# SERVICE BULLETIN

Supplement No. 1

Service Bulletin No. 475C

**REASON FOR SUPPLEMENT:** Provide an alternate method of compliance to Service Bulletin No. 475C if the crankshaft gear is replaced rather than modified.

**Figure 1**  
**Crankshaft Gear Bolt and Lockplate**

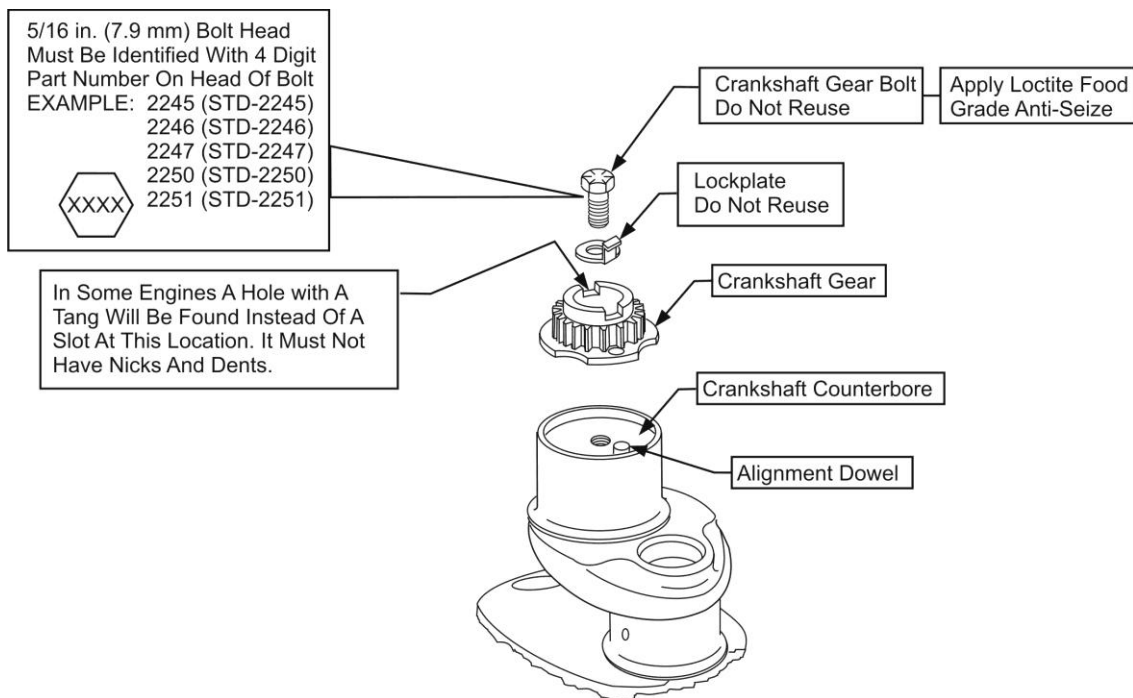
**NOTICE:** Any time the crankshaft gear bolt (Figure 1) and lockplate are removed from the crankshaft gear, the bolt and lockplate are to be discarded and replaced with a new bolt and new lockplate for the applicable crankshaft gear. The discarded bolt and lockplate are not to be re-installed on any engine.

- Remove the crankshaft gear bolt, lockplate, and crankshaft gear from the crankshaft (Figure 1). Discard the bolt and the lockplate.

**⚠ CAUTION:** DURING CRANKSHAFT ASSEMBLY, ALWAYS INSTALL A NEW CRANKSHAFT GEAR BOLT AND NEW LOCKPLATE. PER FAA DIRECTIVE, DO NOT RE-INSTALL A CRANKSHAFT GEAR BOLT OR LOCKPLATE (THAT HAD BEEN IN SERVICE) ON ANY ENGINE.

**Figure 5**  
**Details for Crankshaft Gears to Current Configuration**

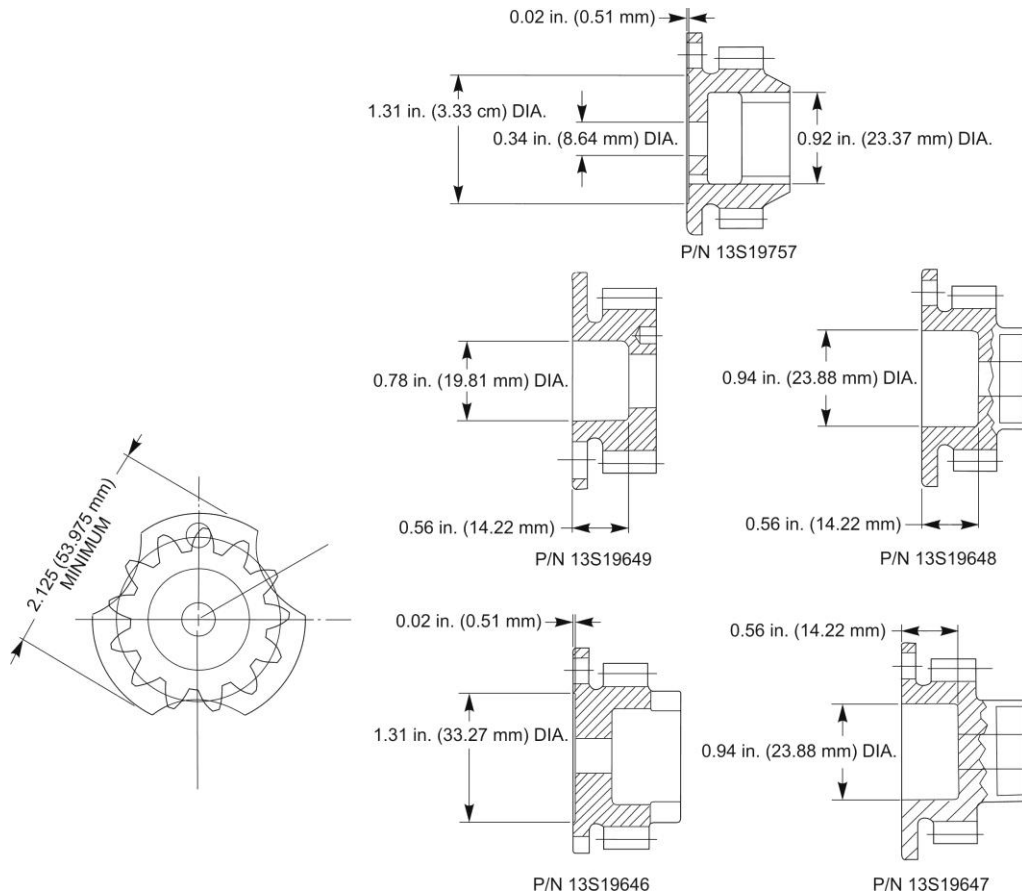
If the crankshaft gear does not have the larger three scallops as shown in Figure 4 and looks like either crankshaft gear shown in Figure 2 or Figure 3, discard the crankshaft gear and replace it with a new crankshaft gear with the larger scallops as shown in Figure 4. Refer to Table 2 and Figure 5 to identify the correct replacement crankshaft gear.

If the crankshaft gear looks like the large scallop pilot flange-type crankshaft gear (P/Ns 13S19646 and 13S19757) shown in Figure 4, make sure the gear has the 0.02 in. (0.51 mm) cut on the underside of the gear as shown in Figure 5. Otherwise, replace with a serviceable crankshaft gear.

3. Measure the diameter of the crankshaft gear pilot flange. If the diameter of the pilot flange is less than 2.125 in. (53.975 mm) (Figure 5), do not install this gear on the crankshaft. Replace the crankshaft gear with a serviceable crankshaft gear.

4. Measure the dimensions on the crankshaft gear as per those shown in Figure 5 for the respective crankshaft gear part number in Table 2.
5. Complete a magnetic particle inspection on the crankshaft gear anytime the crankshaft gear is removed. Refer to the latest revision of Service Instruction No. SI-1285.

**Figure 6**  
**Section Through Crankshaft Counterbore End of Crankshaft Showing Driven Height of STD-1065 Alignment Dowel**

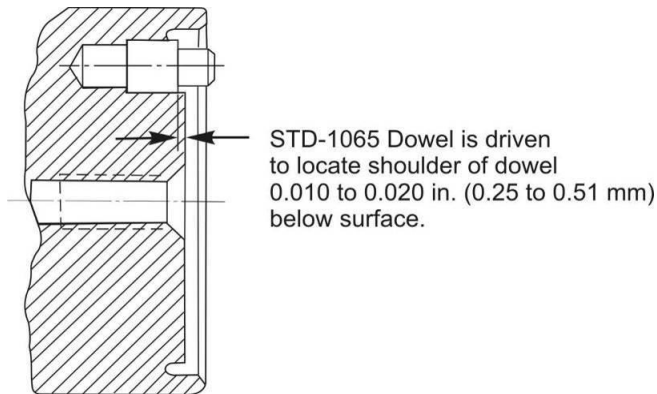
3. If the alignment dowel is smooth and round, make sure that it is installed correctly, by the following measurements.
  - A. Figure 6 for STD-1065-type alignment dowels, the shoulder of the alignment dowel is 0.010 to 0.020 in. (0.25 to 0.51 mm) below the surface of the crankshaft.
  - B. Figure 7 for alignment dowels STD-2078 shows that the end of the alignment dowel is 0.160 ± 0.010 in. (4.06 ± 0.254 mm) above the counterbore surface of the crankshaft.
4. Measure the diameter of the alignment dowel (Dimension A) shown in Figure 8 and determine if the measurement conforms to the values in Table 3 for the different alignment dowel part numbers.
5. If the alignment dowel is out of tolerance, out of round, or damaged, replace the alignment dowel with a new one as per instructions in the section “Alignment Dowel Replacement.”

11. Press the replacement alignment dowel into the alignment dowel hole, refer to Figure 6 or 7 for the correct driven height of the applicable alignment dowel.

**Figure 9**  
**Crankshaft Gear Position**

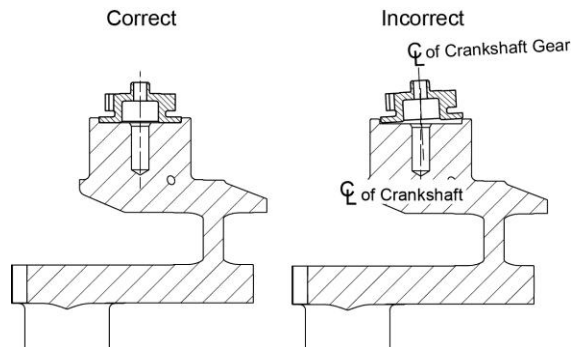
**⚠ CAUTION:** FOR CORRECT ENGINE OPERATION, THE CRANKSHAFT GEAR MUST BE INSTALLED CORRECTLY WITH NO GAP BETWEEN THE MATING SURFACES OF THE COUNTERBORED-END OF THE CRANKSHAFT AND THE CRANKSHAFT GEAR PILOT FLANGE (FIGURE 9).

9. Make sure the crankshaft gear seats firmly and is perpendicular (not at a slanted angle) to the crankshaft as shown in Figure 9:
  - A. Try to put a pointed 0.001 in. (0.025 mm) feeler gage or shim stock between the crankshaft gear pilot flange and crankshaft counterbore at each of the three scallops on the crankshaft gear pilot flange. The feeler gage must NOT fit between the two surfaces at any location. There must not be any clearance between the crankshaft and crankshaft gear pilot flange.

- B. If clearance is found, remove the crankshaft gear bolt, lockplate, and crankshaft gear.
  - C. Make sure the mating surfaces of the crankshaft gear and crankshaft counterbore are clean and dry and that there is no debris.

- D. Reinstall the crankshaft gear, lockplate, and crankshaft gear bolt. Repeat the initial torque and seating check above.
  - E. Try again to put a pointed 0.001 in. (0.025 mm) feeler gage or shim stock between the crankshaft gear pilot flange and crankshaft counterbore at each of the three scallops on the crankshaft gear pilot flange.

- F. If there is still clearance, replace the crankshaft gear.
  - G. If there was no clearance, the crankshaft gear is seated correctly. Complete the final torque of the crankshaft gear bolt.
